## Product Change Notice

PCN#: EE-PCN22020

Body dimension change and Packaging change

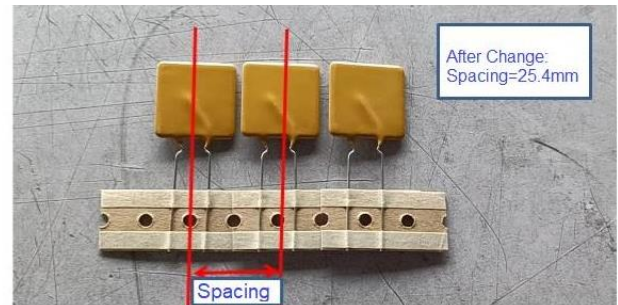
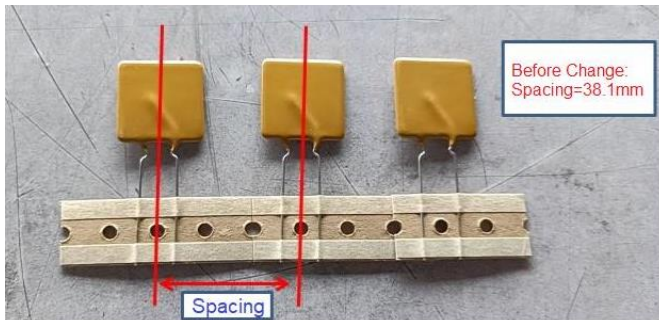
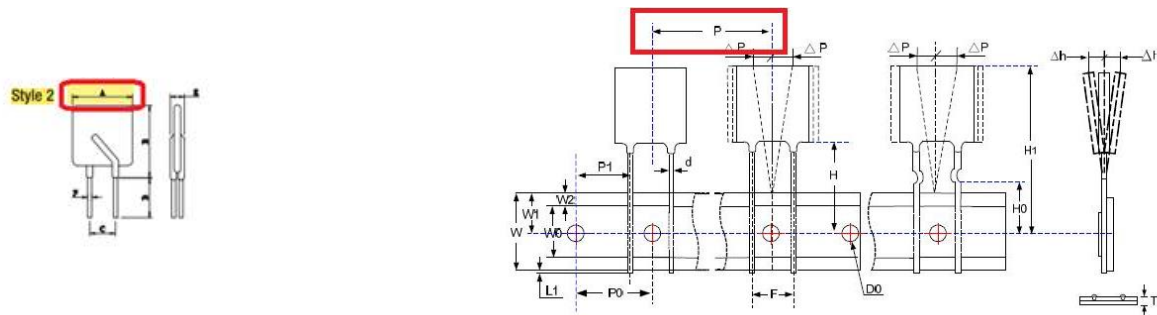
Changing Amax dimension from 25.1mm to 24.4mm and changing the P dimension from 38.1mm to 25.4 +1/-0.5 mm for PTR016V1500-TR1 and PTR016V1500-TR
